To: John Gunn, Chair, and the City of Beacon Planning Board

Date: June 6, 2019

Re: **184 Main Street Site Plan**

I have reviewed the response letter from Alfandre Architecture, revised Full EAF Parts 1 and 2, and a 2-sheet Site Plan set, all dated May 24, 2019.

1979 Beacon Historic Survey Form

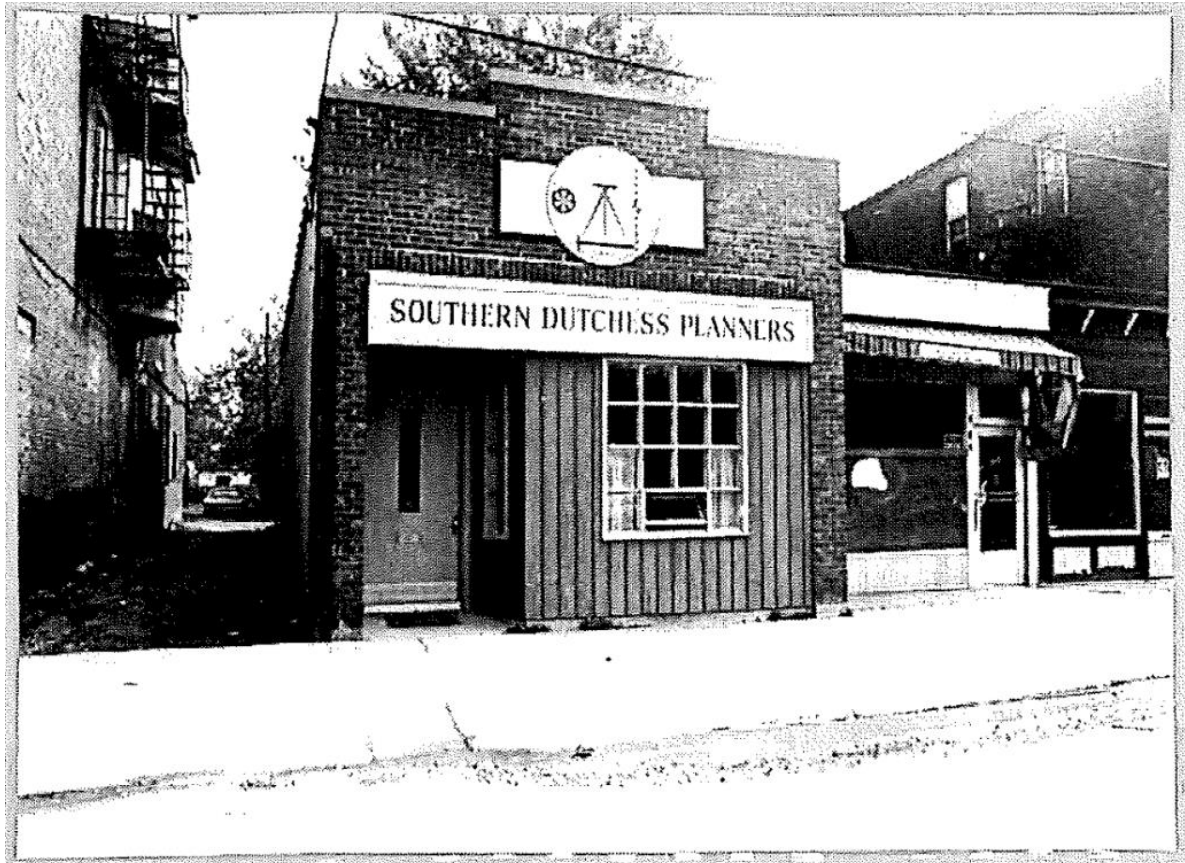
2. Based on a photo from the 1979 Historic Survey (see below), the current storefront is newer, but more historically compatible. The 1979 door was on the west side, as now proposed. The primary remaining historic elements are the brick façade surrounding the storefront and the simple, stepped roofline. The building design should maintain these original features. The apparent height and window sizes on the new second floor should not exceed the first floor. Any new storefront “shall build on the historic context with applications required to demonstrate aspects of inspiration or similarities to adjacent HDLO structures or historic buildings in the surrounding area” (see 134-7 B(1)(a)). The Board may refer the design to the Architectural Review Subcommittee.
